Product Change Notification / LIAL-23YFIV099

CCB 5319 Final Notice: Qualification of MMT as an additional final test site for ATWILC1000, ATWINC15x0, ATWILC3000 and ATWINC3400 device families available in 36L and 28L module package.

CCB 5319

PCN# LIAL-23YFIV099

Tray Comparison

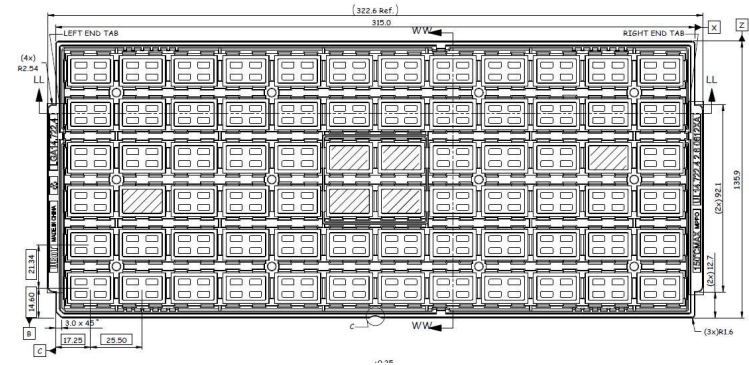
Pre Change

Media	Style	Bake?	Units per Tray	Dimensions	Color
Tray	PET Clear Tray	Not Bakeable	50	142x330mm	Transparent

Post Change

Media	Style	Bake?	Units per Tray	Dimensions	Color
Tray	Jedec Tray	Bakeable	72	135.9x322.6mm	Black

Tray Comparison

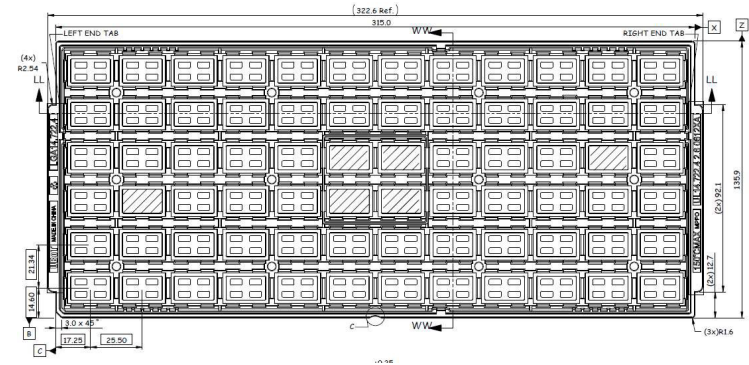
Pre Change

Media	Style	Bake?	Units per Tray	Dimensions	Color
Tray	PET Clear Tray	Not Bakeable	50	142x330mm	Transparent

Post Change

Media	Style	Bake?	Units per Tray	Dimensions	Color
Tray	Jedec Tray	Bakeable	72	135.9x322.6mm	Black
